**SUNDRY NOTICES AND REPORTS ON WELLS**  
*Do not use this form for proposals to drill or to re-enter an abandoned well. Use form 3160-3 (APD) for such proposals.*

8. Well Name and No.  
GALLEGOS CANYON UNIT 66

## **Plug And Abandonment Procedure**

Re: Permanent Abandonment  
Well: GCU #66

# Wellbore Diagram

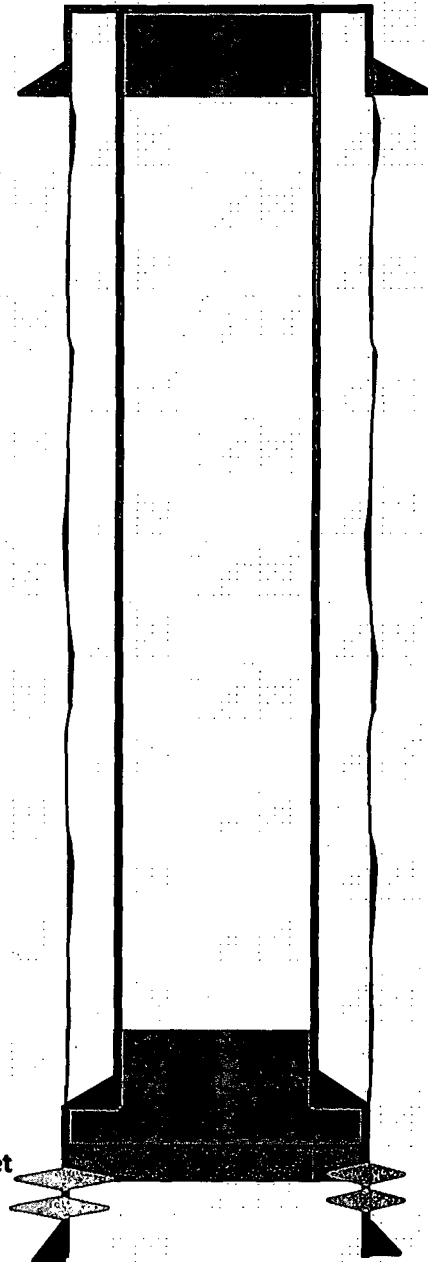
1. Set Plug# 1 (1448'- 1168'), to cover the top of Fruitland Formation. BLM picked the top the Fruitland Formation at 1218' ft.
2. Set Plug# 1 (331'- 0'), to cover the top of Fruitland Formation. BLM picked the top the Kirtland at 281' ft and the Ojo Alamo at 102' ft.
